# SERVICE BULLETIN

No. 547

Piper Aircraft Corporation

Inspection of Stabilator Tip Rib

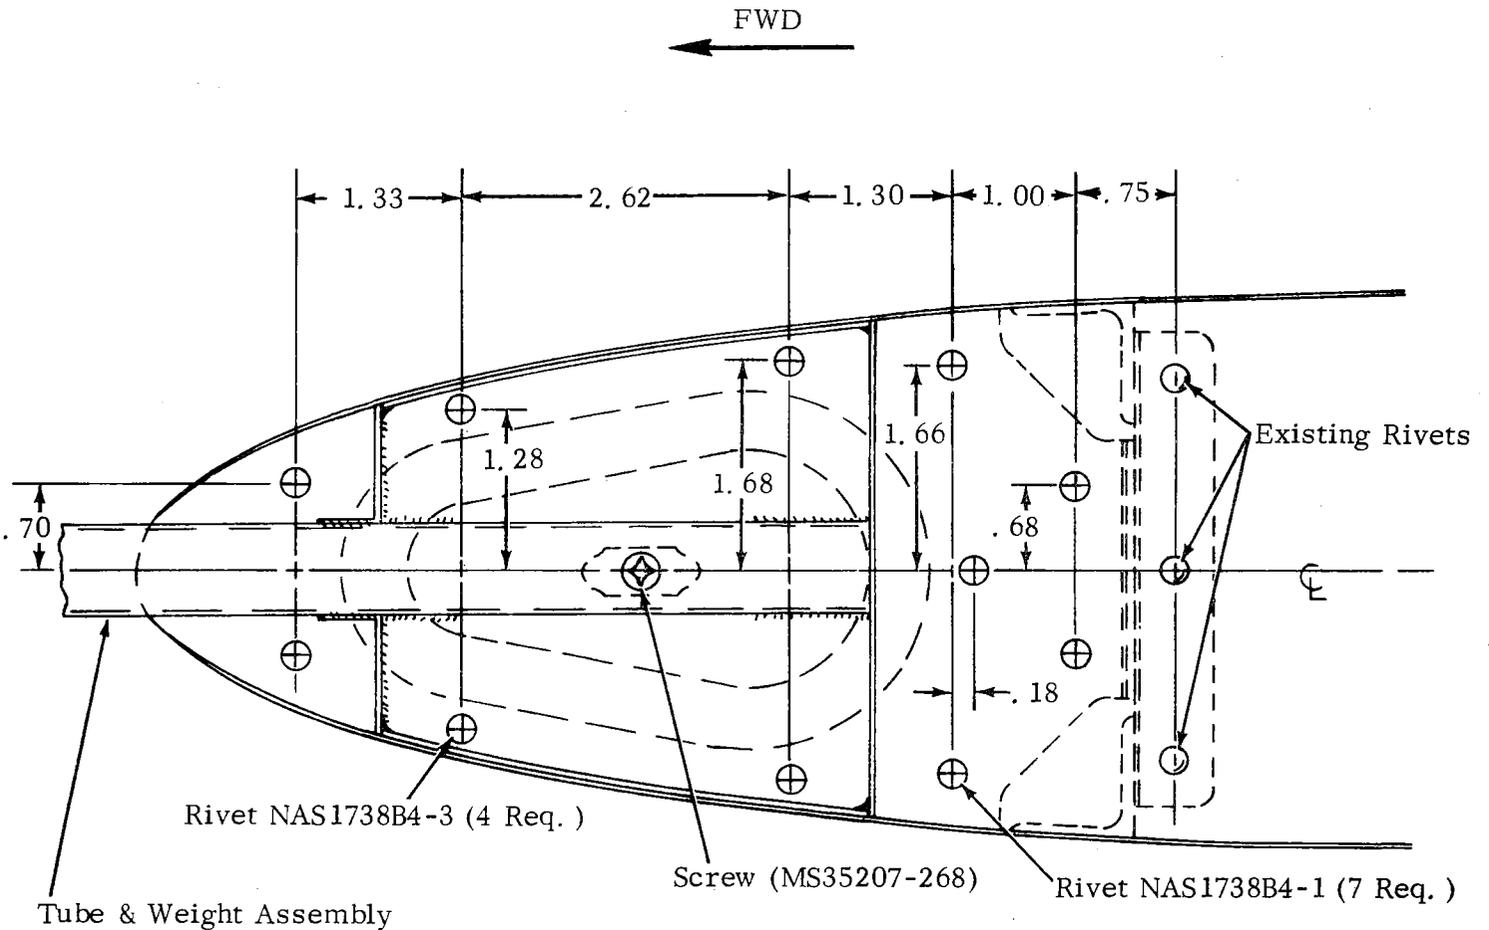
Purpose: Resulting from the inspection specified in Piper Service Bulletin No. 540 dated January 4, 1977, it was found that certain stabilator tip rib rivets and/or the stabilator tip tube and weight assembly attachment screw may be missing. Although no failures have been reported as a result of this condition, inattention to this matter could lead to cracking in the stabilator tip rib area.

This Service Bulletin provides instructions to inspect the stabilator tip rib area to determine that the correct attachment hardware is installed and specifies proper hardware to be installed, if necessary (refer to attached sketch/instruction sheet for an illustrated view of this area).

1. Remove tip assembly from left and right stabilators.
2. Inspect forward end of stabilator ribs to determine if five rivets are installed aft of the tube & weight assembly attachment plate, two rivets installed forward of the attachment plate and a screw installed thru the square tube welded to the attachment plate.

3. If screw and rivets are present on both stabilators, reinstall tip assemblies and make proper logbook entry of Service Bulletin 547 inspection compliance.

4. If screw and rivets are missing from either stabilator, install new hardware as follows:
  - a. Install MS35207-268 screw (P/N 411 537) thru the square tube and into the anchor nut as shown.

- b. Locate and drill eleven .144 holes as shown above.
  - c. Install four NAS1738B4-3 blind rivets (P/N 522 883) at the attachment plate and seven NAS1738B4-1 blind rivets (P/N 522 881) aft and forward of the attachment plate.

- d. Reinstall tip assembly and make proper logbook entry of stabilator rivet and screw installation per Service Bulletin 547.
